Document Type: Change Order Memorandum  
Subject: Change Order 01  
Project: CR 58  
Description: Cement Stabilized Sand for Drainage Structures

**Project:** CR 58 Widening From CR 48 to Sav

# CONSTRUCTION CONTRACT CHANGE ORDER NUMBER: 001

FILE: STDE1.DGN	DN: TxDot	CK: TxDot	DW: TxDot	CR: TxDot
© TxDOT FEB 2010	DIST	FED REG	PROJECT NO.	SHEET
REVISED 11/05	HOUSTON	6	STP 1702 (437) MM	152A
REVISED 2/2010 Added note to Table 1, Sht 2 of 2.	COUNTY	CONTROL	SECT	JOB HIGHWAY
REVISED 6/12	BRAZORIA	0912	31	304CR 58

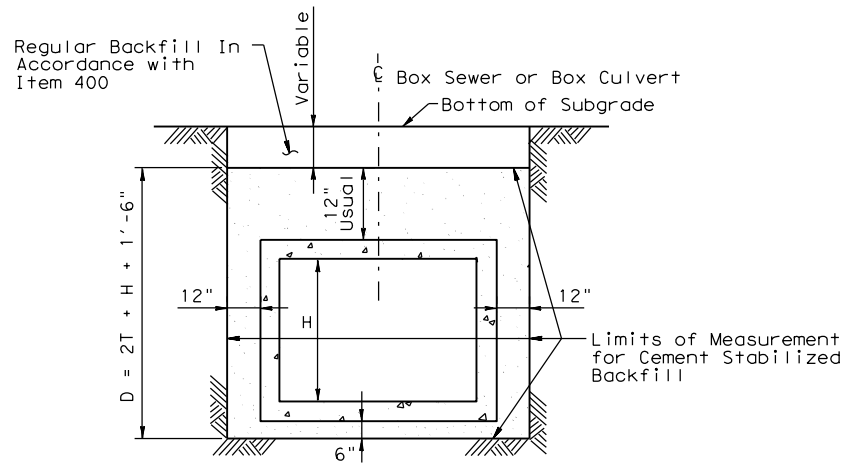
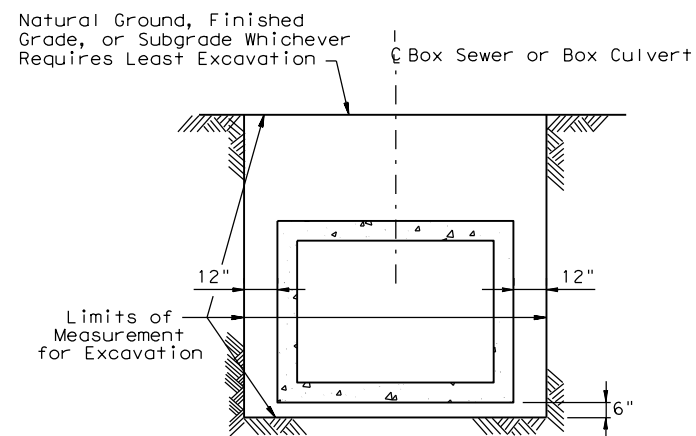
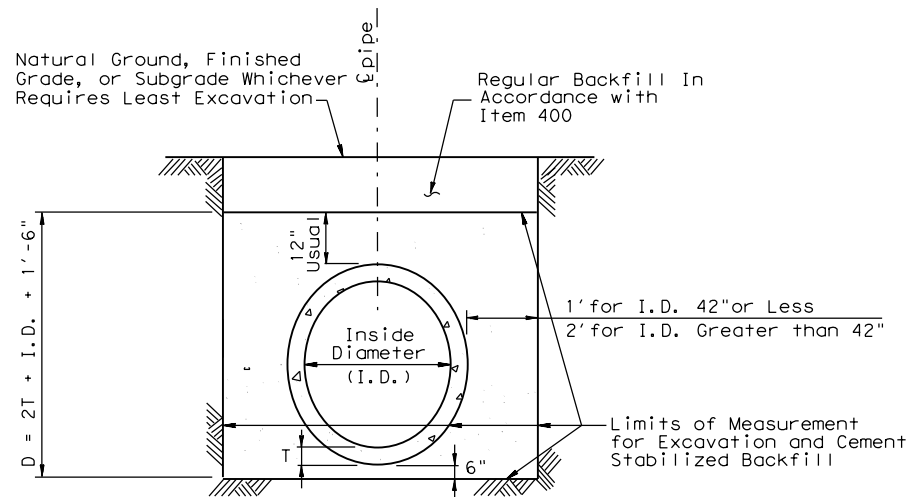
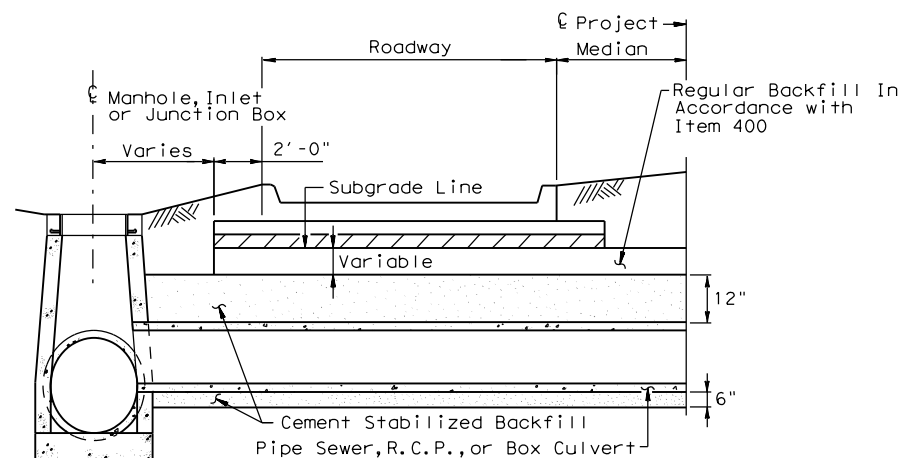
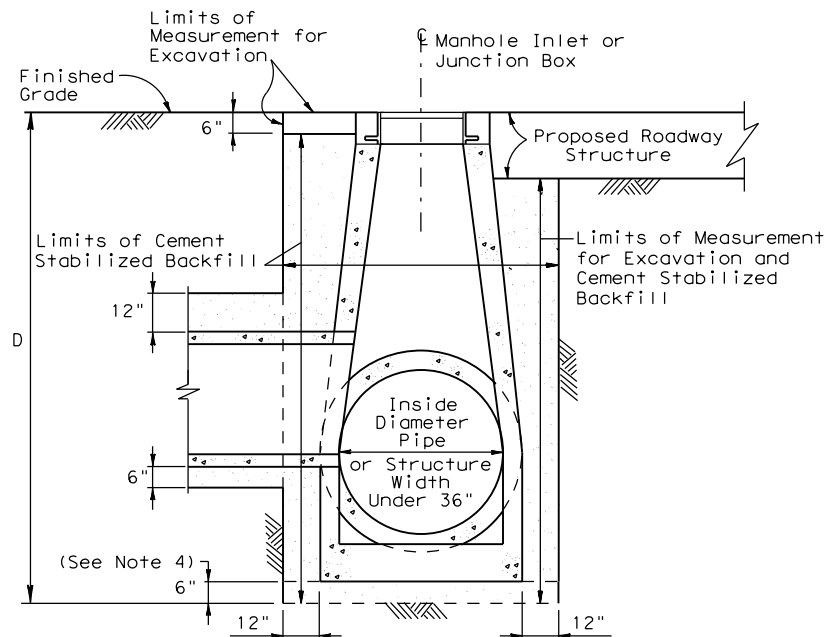
This change order adds plan sheets 152A and 152B.

The project plans did not include a quantity for cement stabilized sand to backfill the drainage structures on the project. Therefore, this change order adds item 400-6005 "CEM STABIL BKFL" at a quantity of 1660 CY to backfill the drainage structures.

5. New or revised plan sheet(s) are attached and numbered: 152A and 152B
